Title - Sujet CCG College: Roof Replacement	
Solicitation No. - N° de l'invitation EB144-151989/A	Amendment No. - N° modif. 002
Client Reference No. - N° de référence du client EB144-15-1989	Date 2015-03-02
GETS Reference No. - N° de référence de SEAG PW-\$PWA-121-5200	
File No. - N° de dossier PWA-4-72085 (121)	CCC No./N° CCC - FMS No./N° VME
Solicitation Closes - L'invitation prend fin at - à 02:00 PM on - le 2015-03-05	
Time Zone Fuseau horaire Atlantic Standard Time AST	
F.O.B. - F.A.B. Plant-Usine: <input type="checkbox"/> Destination: <input checked="" type="checkbox"/> Other-Autre: <input type="checkbox"/>	
Address Enquiries to: - Adresser toutes questions à: Russell (PWA), Alex	Buyer Id - Id de l'acheteur pwa121
Telephone No. - N° de téléphone (902) 496-5168 ()	FAX No. - N° de FAX (902) 496-5016
Destination - of Goods, Services, and Construction: Destination - des biens, services et construction:

Amendment 002 is raised for the following:

2.0 Questions and Answers

2.1 DRAWING S1.3 – STRUCTURAL REPAIR DETAILS SHEET 1 OF 2

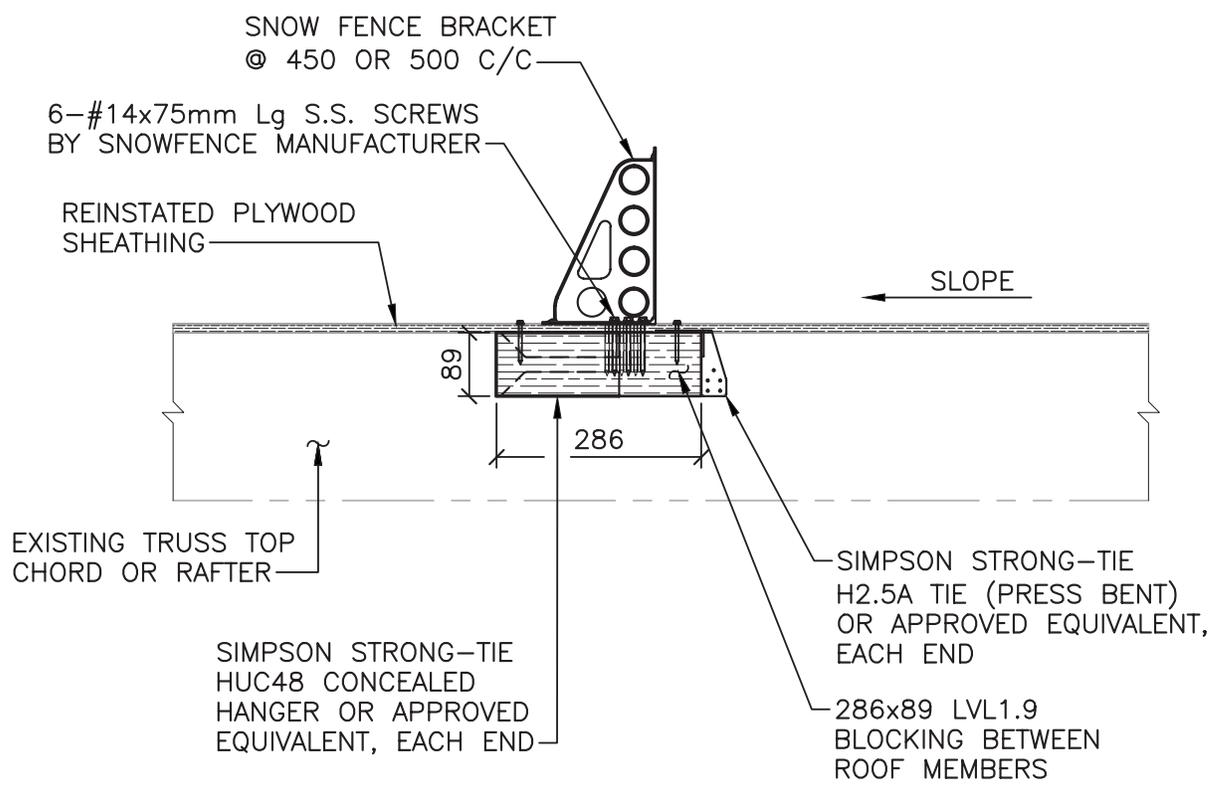
- .1 Add Structural Detail for snow fence support for timber framed buildings. See Structural Detail SK1.5 – SNOW FENCE SUPPORT TIMBER FRAMED BUILDINGS.

<p>CBCL LIMITED Consulting Engineers ISO 9001 CERTIFIED</p>	<p>Public Works and Government Services Canada</p> <p>Travaux Publics et Services gouvernementaux Canada</p>	<p>Drawing</p> <h1 style="font-size: 2em;">SK1.6</h1>
<p>SNOW FENCE SUPPORT METAL FRAMED BUILDINGS</p>

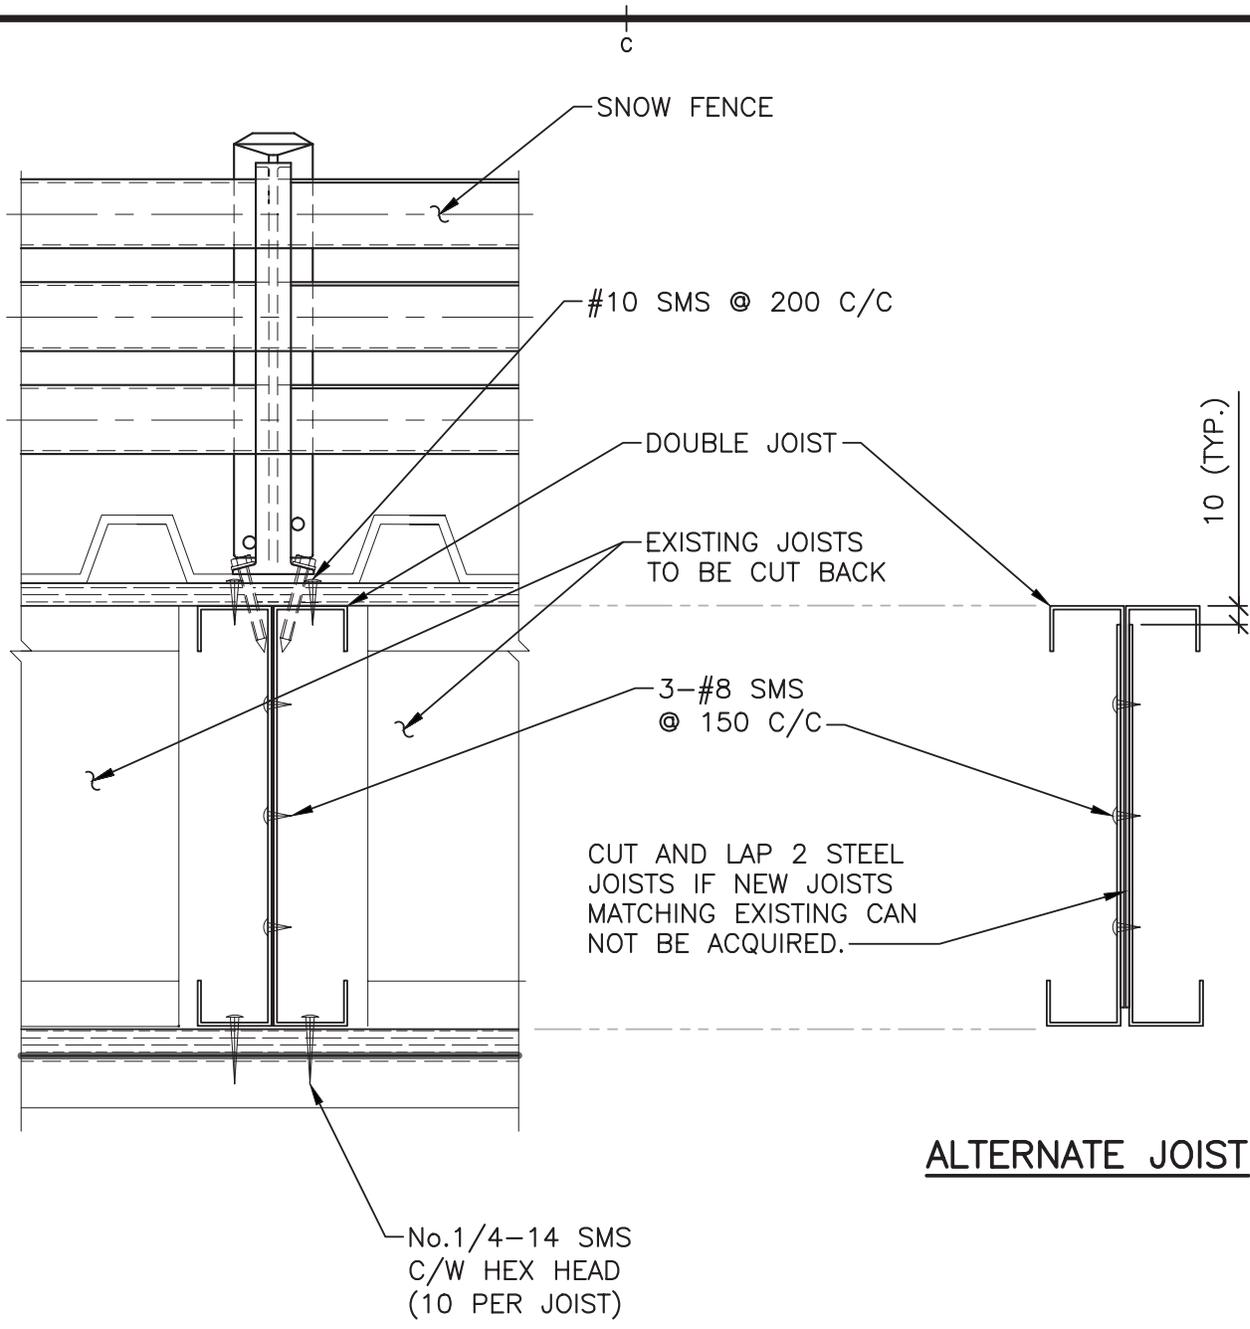
- .1 Add Structural Details for snow fence support for steel framed buildings. See Structural Details SK1.6 – SNOW FENCE SUPPORT METAL FRAMED BUILDINGS and SK1.7 – SNOW FENCE SECTION AND DETAILS.

Drawing
SK1.8

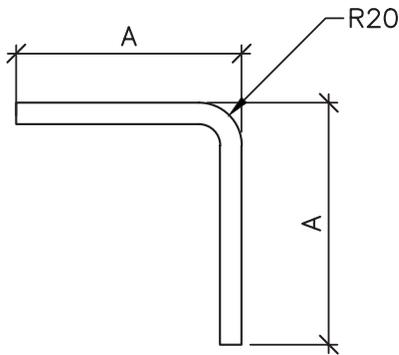
6. Question: Concerns regarding interior Cabot Building Structural repairs. Some beams and joist have interior partition walls or exterior load bearing walls under them, limiting space for welding bottom chord reinforcing, without removal of existing walls and services. Please confirm?
Answer: For W Section Reinforcing, contractor to do minimal removals of any interior wall that is underside of beam and use Alternate detail to 5A on Drawing S1.4 (See Structural Details SK1.8 and SK1.9 by attached Addendum #1.
